Sydney Metro City & Southwest

Pitt Street South Over Station Development:

Crime Prevention Through Environmental Design Report

Applicable to:	Sydney Metro City & Southwest
Author:	GHD Pty Ltd
Owner	Sydney Metro
Status:	Final
Version:	4
Date of issue:	August 2018
© Sydney Metro 2018

Figure 8: Pitt Street South OSD Ground Plane Plan

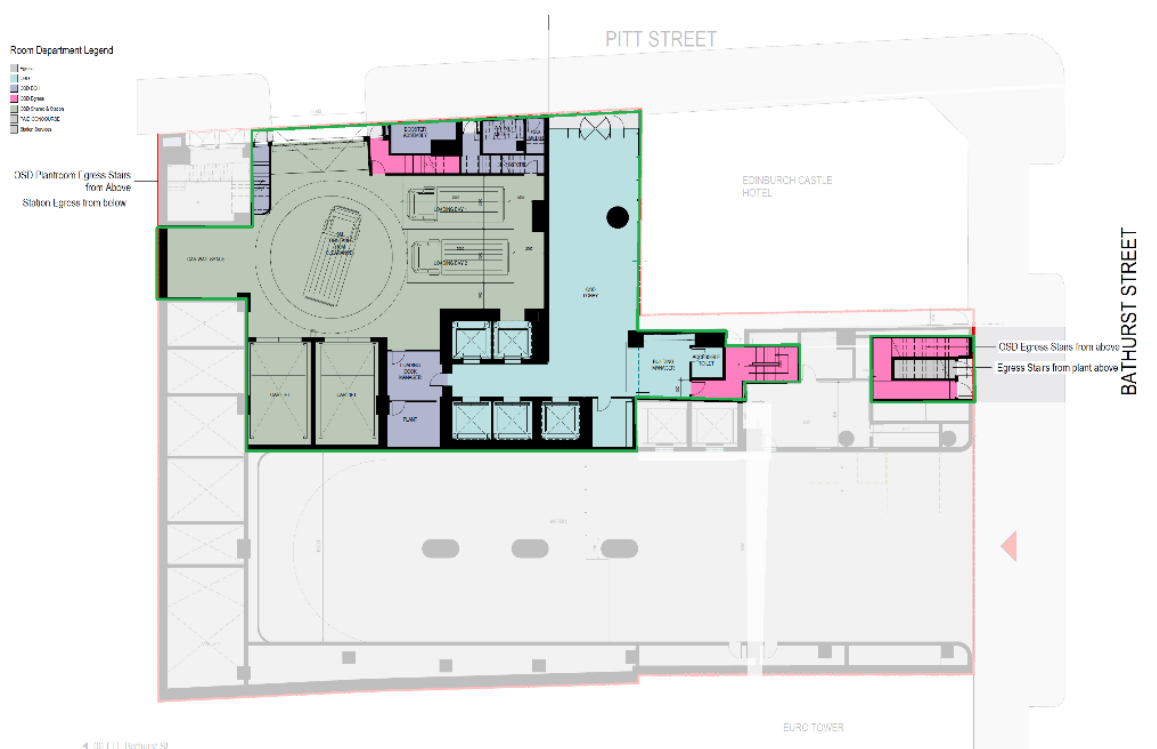
As per **Figure 8** above, these elements of design are within the scope of review and recommendations in this Audit are therefore limited to these areas.

Entry to the Pitt Street OSD (vehicle and pedestrian) and footpath area may be vulnerable to loitering and antisocial behaviour due to the adjacent Edinburgh Castle Hotel. Adequate lighting (minimum 20 lux) is recommended in and around all entry, lobby and car park areas.

Signage of the building name clearly visible from areas of approach towards the building including the Pitt Street footpath is recommended.

The front entry recess indicates a clear transitional zone into the building from the outside Pitt Street footpath area.

Natural Surveillance and clear sightlines have been achieved due to the front façade of the OSD consisting of transparent glass (including glassed doors) for clear visibility from within the ground floor lobby area to the outside Pitt Street area and similarly from the outside area to the inside lobby. This will ensure building users and visitors have clear sightlines to assist with the detection of unauthorised users of the space.

As previously mentioned under **Section 4.1** the front façade area should be well lit to deter entrapment at areas where the building is recessed from the property building line. Consideration should be given to reduce or design out any or all of the recessed areas of the front façade, in particular, the fire escape and booster assembly area. It is also recommended that CCTV cameras are installed to deter and detect acts of crime at the front of the building between Pitt Street and the building façade.
